Re: 2nd Submission Review – Fitzsimons Gateway Affordable Multi-Family – Site Plan Amd. 1
Case Number: 2022-4047-01

Thank you for the comments on the Fitzsimons Gateway Apartments Site Plan which we received on January 2, 2024. We have reviewed all the comments and have addressed them below.

[Site Plan Page 3]

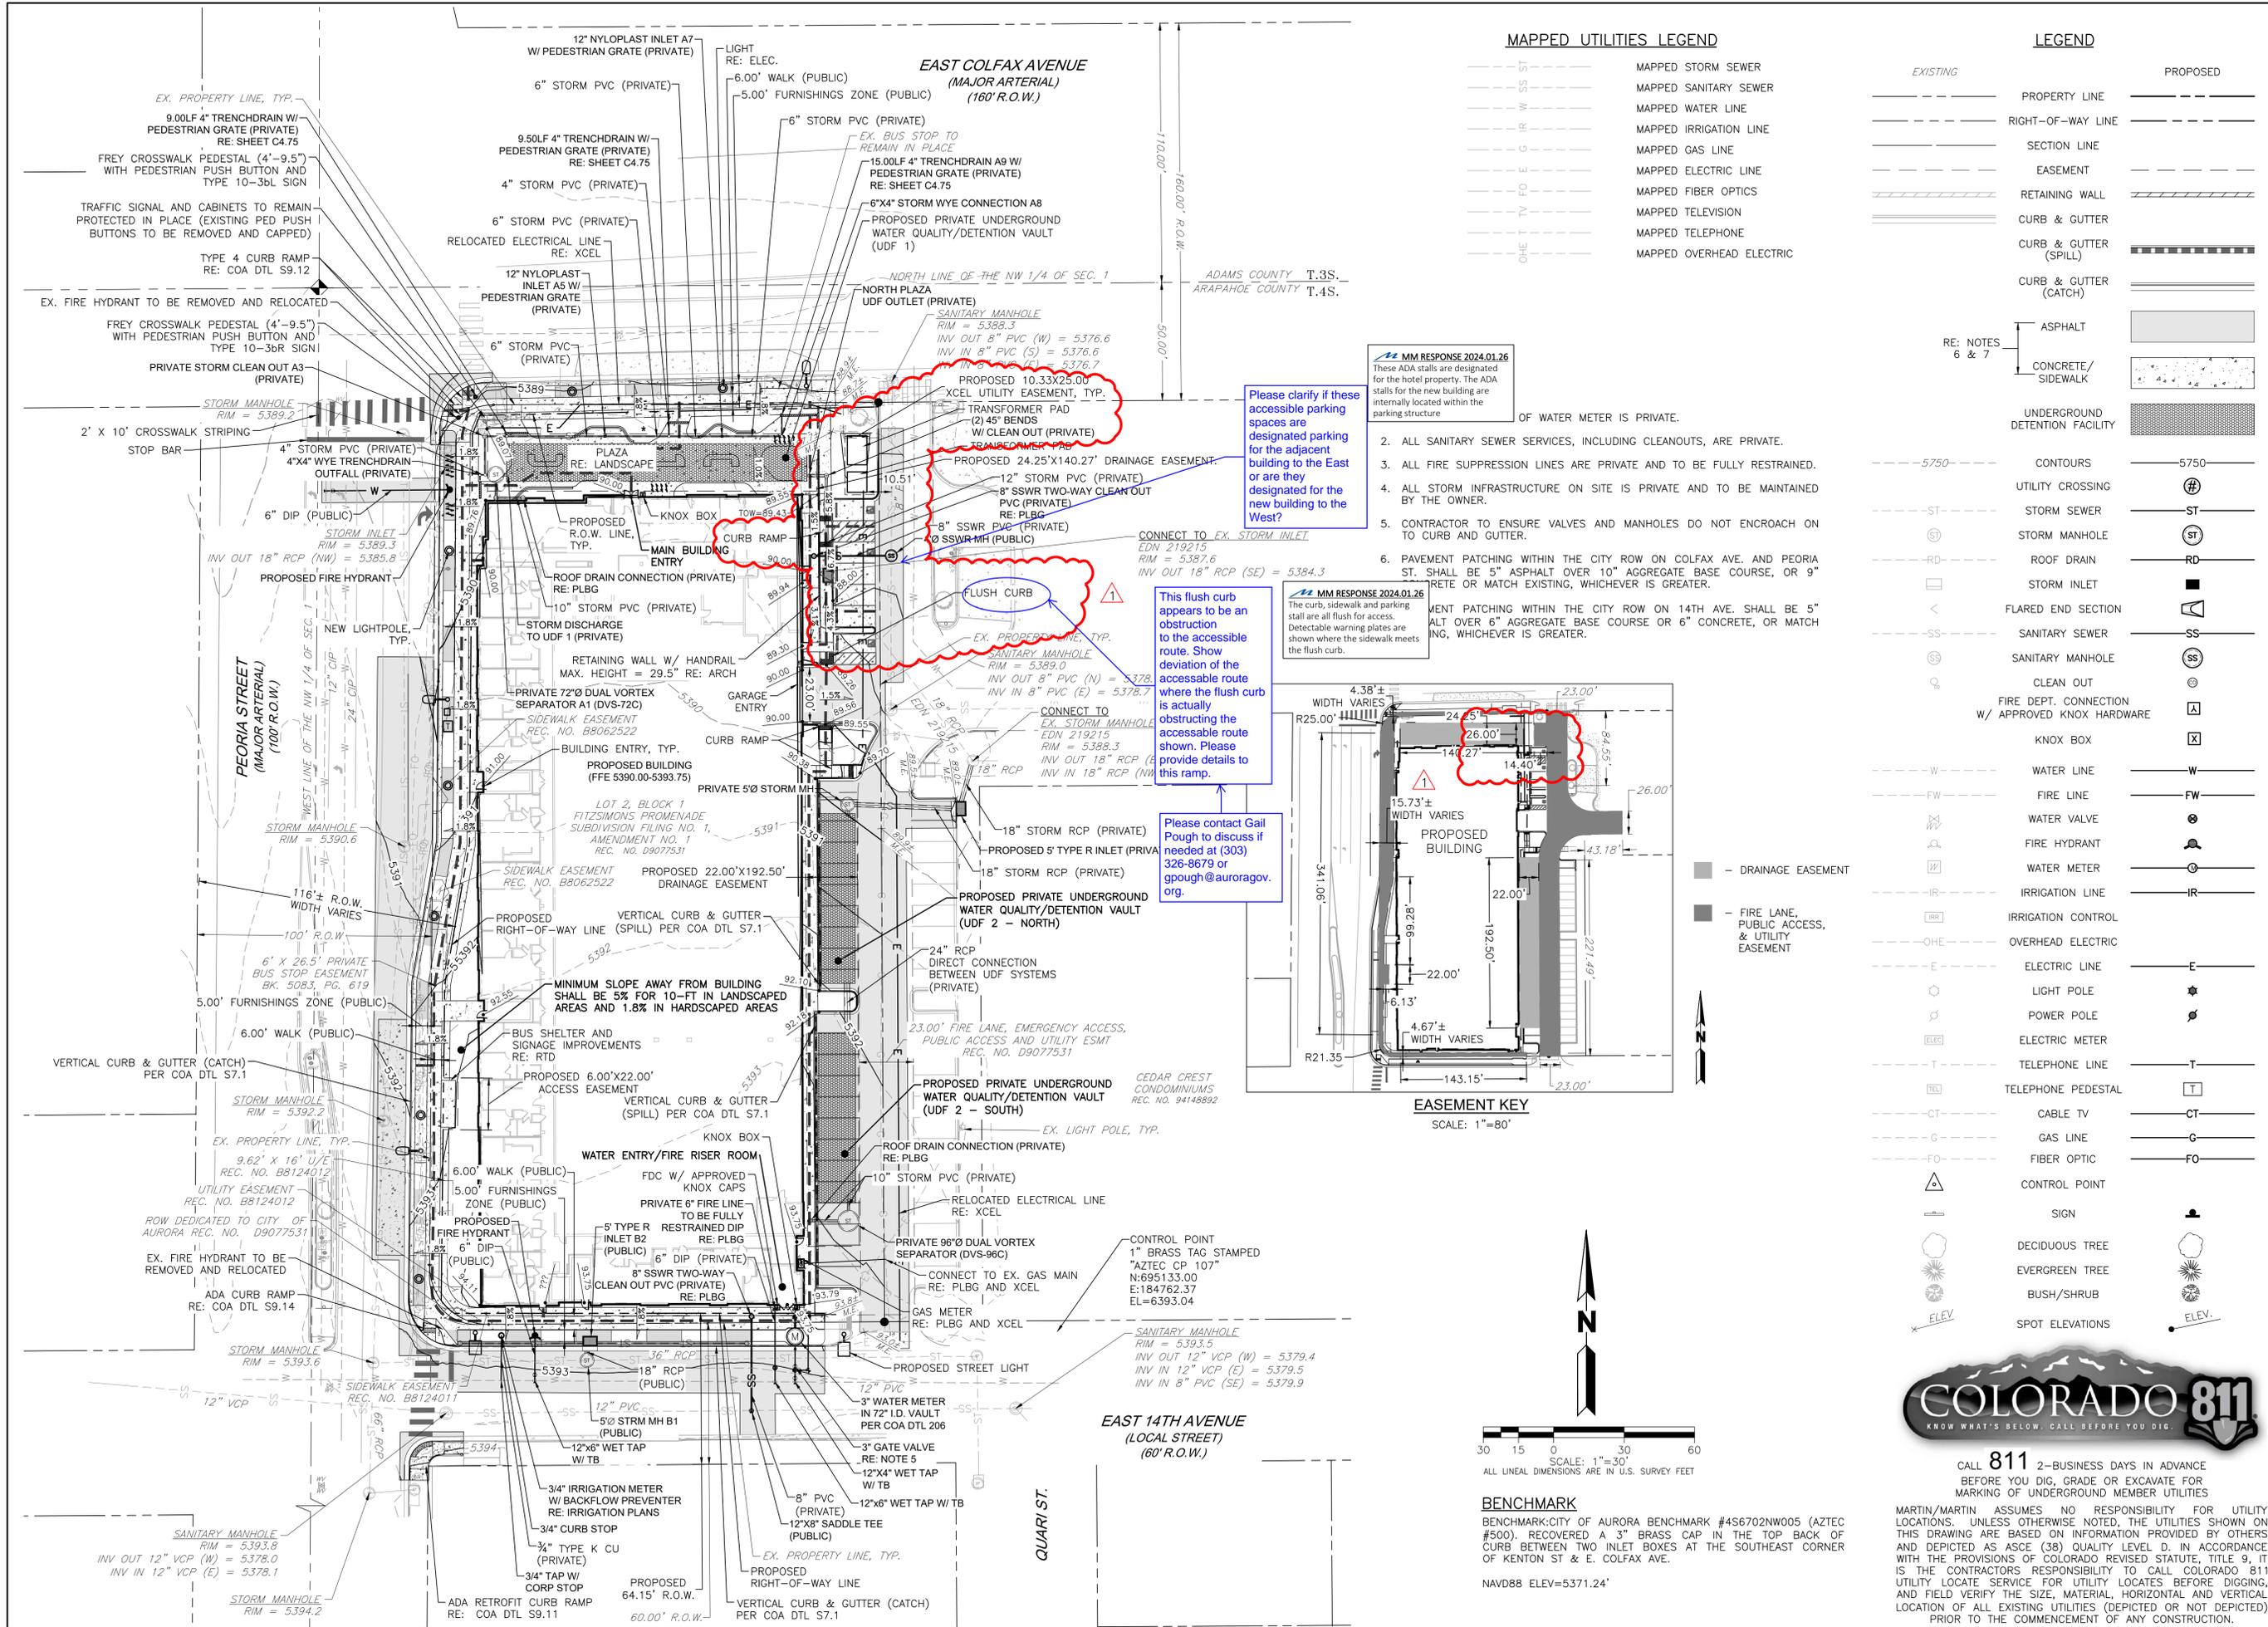
3A. This flush curb appears to be an obstruction to the accessible route. Show deviation of the accessible route where the flush curb is actually obstructing the accessible route shown. Please provide details to this ramp.

3B. Please clarify if these accessible parking spaces are designated parking for the adjacent building to the East or are they designated for the new building to the West?

Please clarify if these accessible parking spaces are designated for the adjacent building to the East or are they designated for the new building to the West?

This flush curb appears to be an obstruction to the accessible route. Show deviation of the accessible route where the flush curb is actually obstructing the accessible route shown. Please provide details to this ramp.

Response: The curb, sidewalk, and parking stall are all flush for access. Detectable warning plats are shown where the sidewalk meets the flush curb.

Response: These ADA stalls are designated for the hotel property. The ADA stalls for the new building are internally located within the parking structure.

MM RESPONSE 2024.01.26
These ADA stalls are designated for the hotel property. The ADA stalls for the new building are internally located within the parking structure.

MM RESPONSE 2024.01.26
The curb, sidewalk and parking stall are all flush for access. Detectable warning plates are shown where the sidewalk meets the flush curb.
